Project Name: **UNIVERSITY OF CALIFORNIA, MERCED**
CLASSROOM & ACADEMIC OFFICE BUILDING
Project No.: **900290**

ADDENDUM NO. 2

February 28, 2014

1 FIRST FLOOR REFLECTED CEILING PLAN

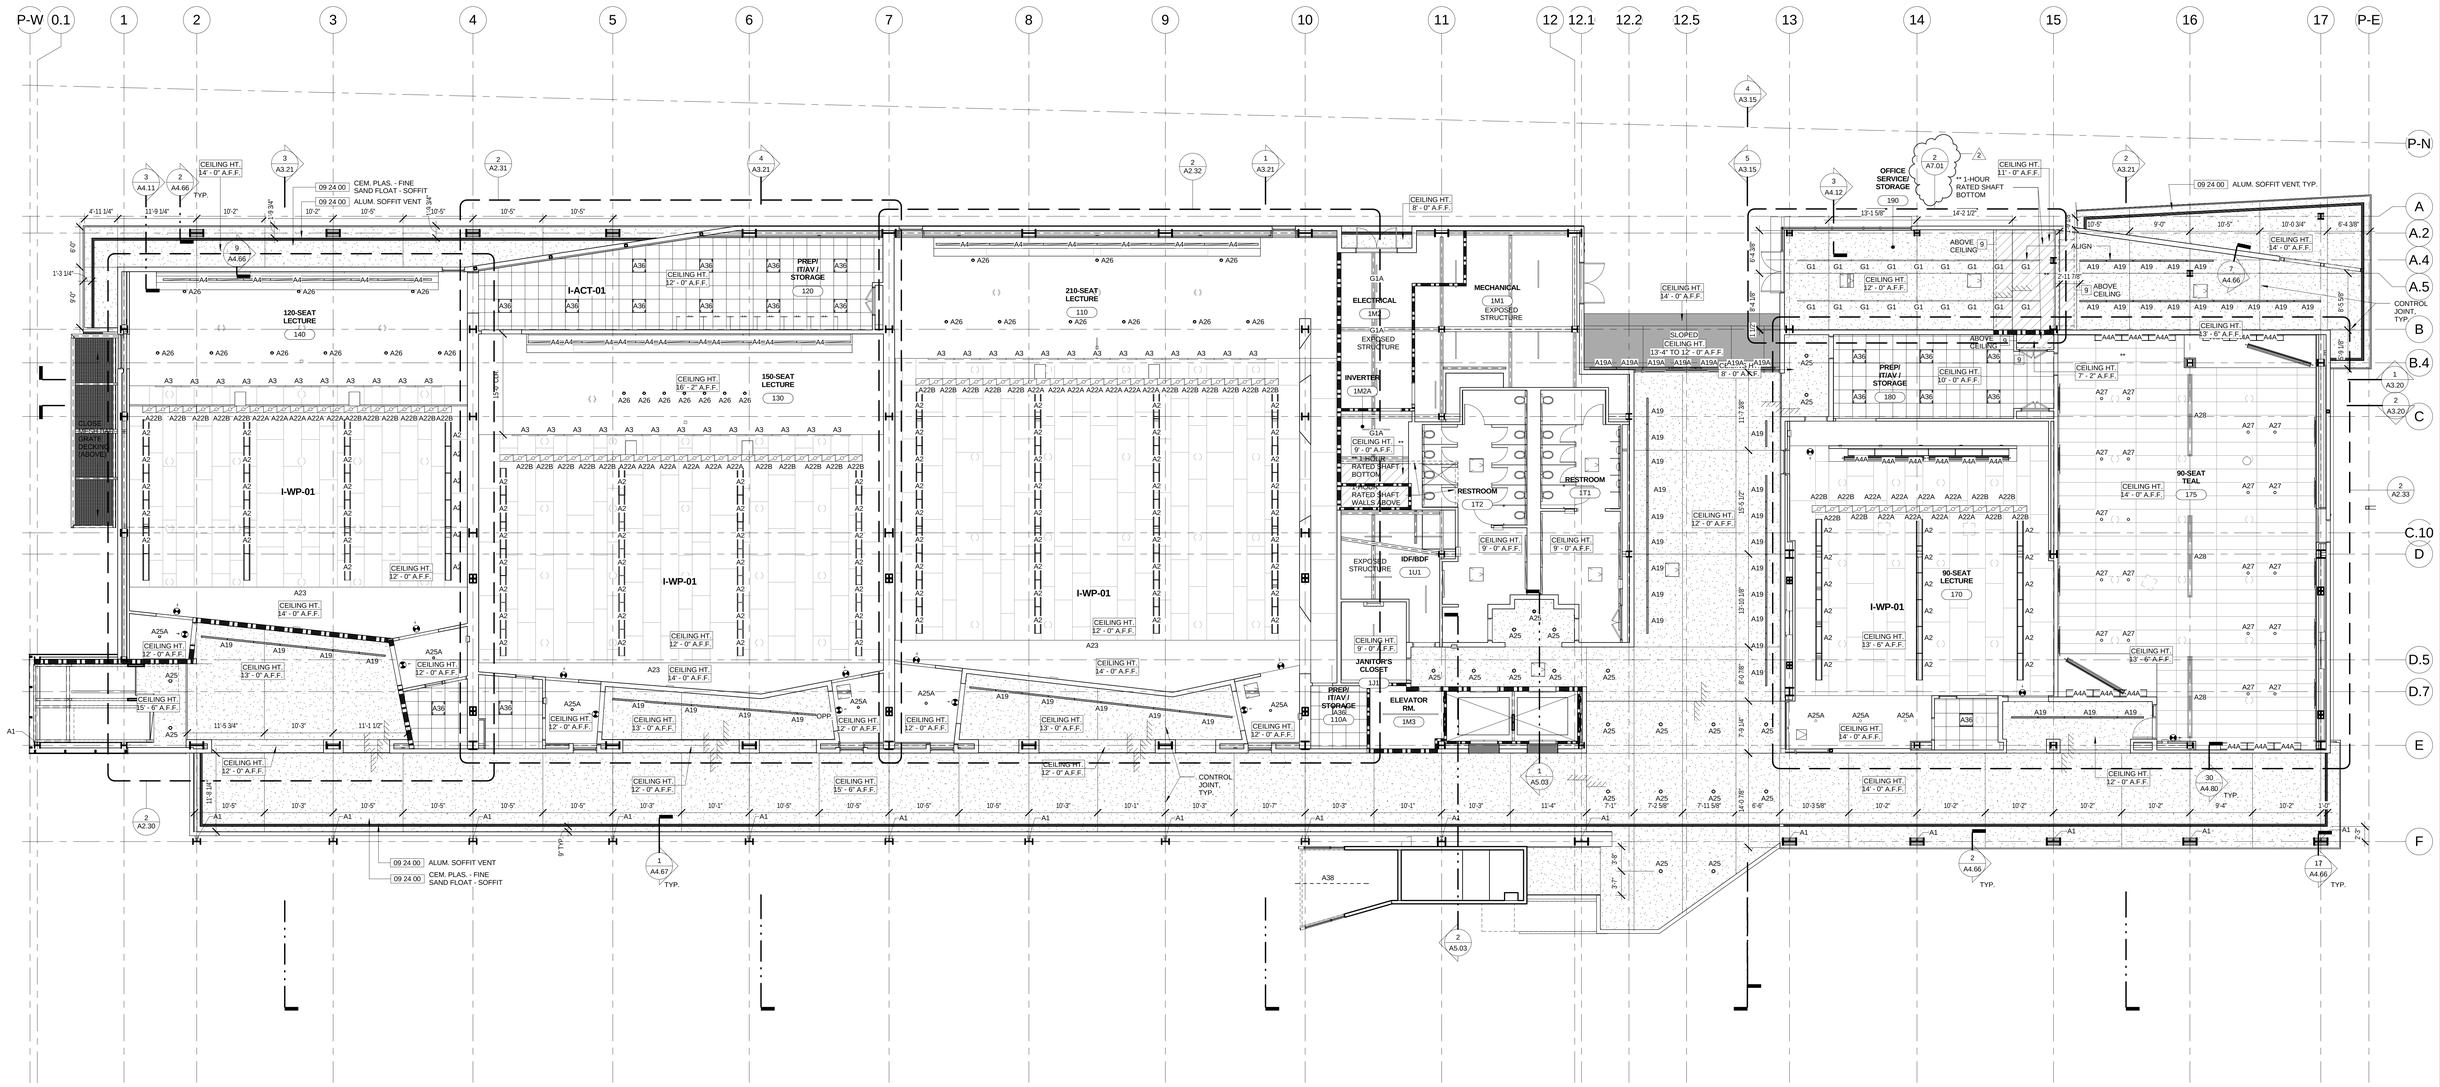
A6.08	INTERIOR ELEVATIONS	Corrections/updates made to interior elevations at Rm 190 base bid. (Clarification)
A7.01	First Floor Reflected Ceiling Plan	Add Alternate #2 RCP callout/plan view added (Add Alt. #2)
A8.30	First Floor Finish Plan & Schedule	Finish legend updated, Rm 190 floor finish and Add Alternate #2 finish added (Add. Alt # 2)
S0.07	Pv Support Loading Criteria	Add sheet defining PV load criteria. (Add. Alt. #3)
S2.01	Foundation & First Floor Framing Plan	Add sheet note 23, add reference to sheet note 23 @ exterior exposed to view pilasters, stem walls, curbs, Stair 1, add clarifying note to detail 2. (Clarification)
S2.03	Third Floor Framing Plan	Remove erroneous callout. Revise beam end connections at tie backs at roof south of Line E. (Correction)
S2.04	Roof Framing Plan	Delete roof beams Line D.5-2, add beam west of Line 2, north of B.5, move screen wall post to D.5-2, add moment connection beam D.5-2. Remove erroneous callout near A-5. (Change to base bid that can accommodate Add. Alt. #3)

PARTIAL PLAN - LANTERN ROOF @ P.V. STRUCTURE 13
1/8" = 1'-0"

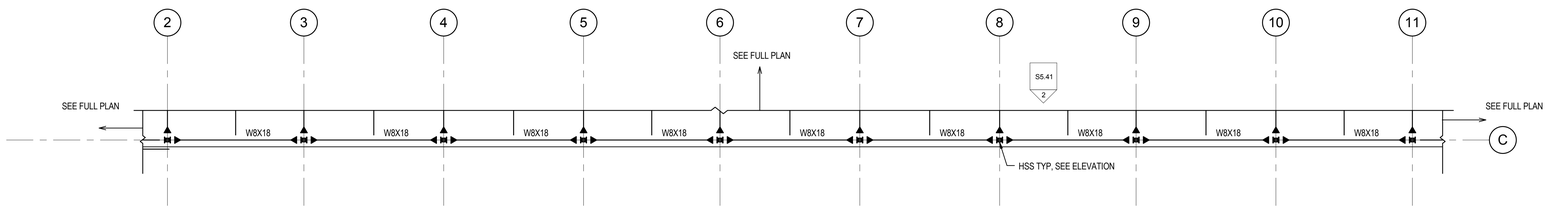
S2.05	Lantern Roof Framing Plan	Revise beam end connections at tie backs at Lantern roof Add partial plan detail 13 showing PV structure. (Add Alt. #3)
S2.06	Mechanical Screen Framing Plan	Revise screen wall framing Line D.5-2. (Change to base bid that can accommodate Add. Alt. #3)
S2.07	Pv Support Framing Plan	Add sheet showing PV support framing (Add Alt #3)
S4.06	Collector Details	Revise detail references in Detail 11. (Clarification)
S5.06	Non-Frame Steel Column Schedule & Details	Minor revisions clarifying column schedule. Add HSS posts to tops of columns Line C, 2 through 11. (Add. Alt. #3)
S5.08	Transfer Girder Details	Revise notes Detail 1. (Clarification)
S5.14	Steel Details	Revise detail references in Detail 12. (Clarification)
S5.31	Mechanical Screen Elevations	Add Detail References in Elevation 1 (Clarification)
S5.32	Mechanical Screen Details	Minor revisions to details 2, 3, 4, 5, add detail 15. (Clarification)

Scale: 1/4" = 1'-0"
Drawn By: Author
Project Number:
Sheet Number: 2 S5.41

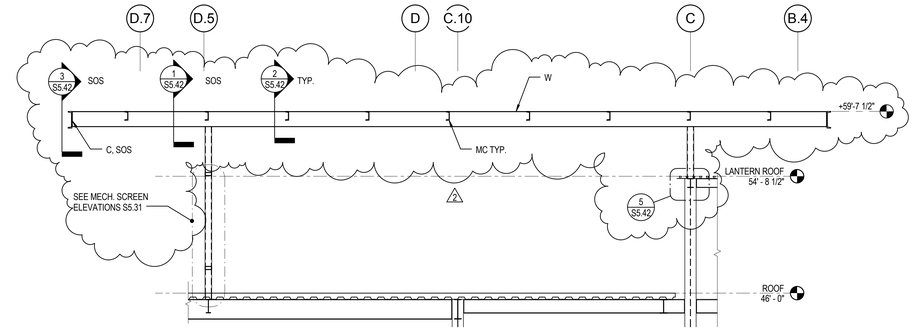
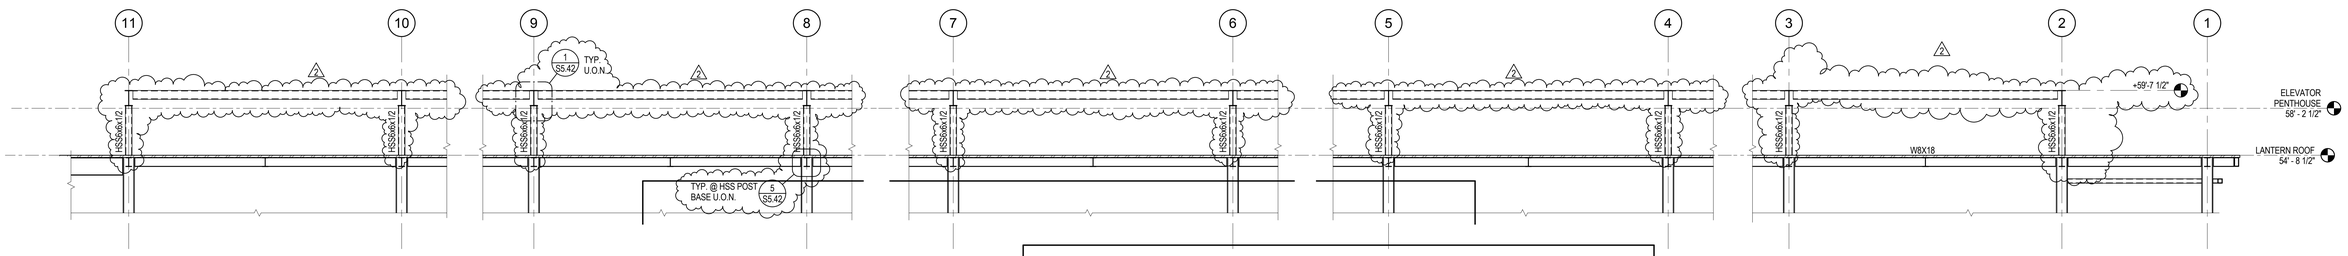
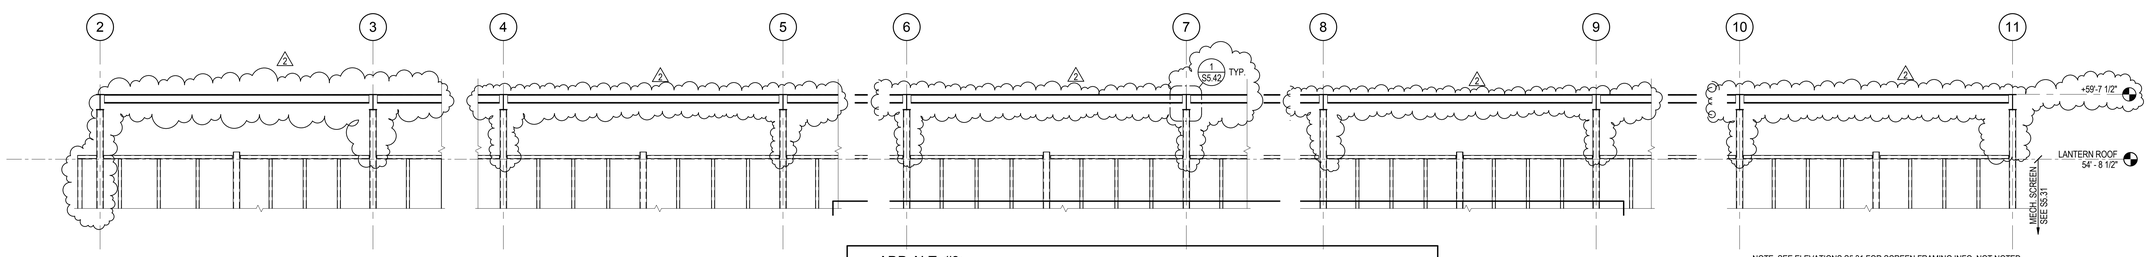
S5.41	Pv Support Framing Elevations	Add sheet - elevations and sections. (Add Alternate #3)
S5.42	Pv Support Framing Details	Add sheet - connections. (Add Alternate #3)
M2.12A	Enlarged Second Floor Plan	Revise perimeter office diffusers direction of throw from 2 to 3. (Clarification)
M2.12B	Enlarged Second Floor Plan	Revise perimeter office
